Change the OVLD state machine to read:

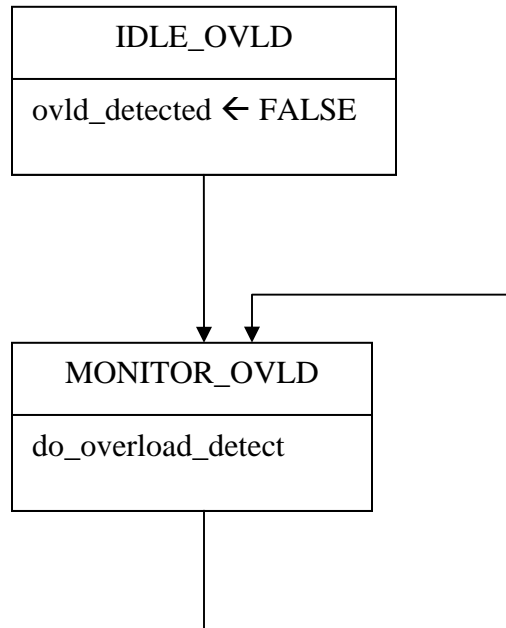
Add a function to the PSE state machine:

`do_overload_detect`:

This function monitors the PSE output current and detects an overload condition for at least 5% of a one second sliding time. This function returns a variable `ovld_detected`.

`ovld_detected` – output of the `do_overload_detect` function

Values:

TRUE: The PSE has detected an overload condition for at least 5% of a one second sliding time.

FALSE: The PSE has not detected a qualified overload condition.

Replace “`toovld_timer_done`” on left hand exit vector of state “`POWER_ON`” with `ovld_detected`.

Replace “`toovld_timer_not_done`” on left center vector exiting “`POWER_ON`” with `!ovld_detected`.

Replace “`toovld_timer_done`” on left hand exit vector of state “`TEST_MODE`” with `ovld_detected`.

Remove timer “`toovld_timer`” from section 33.2.4.5
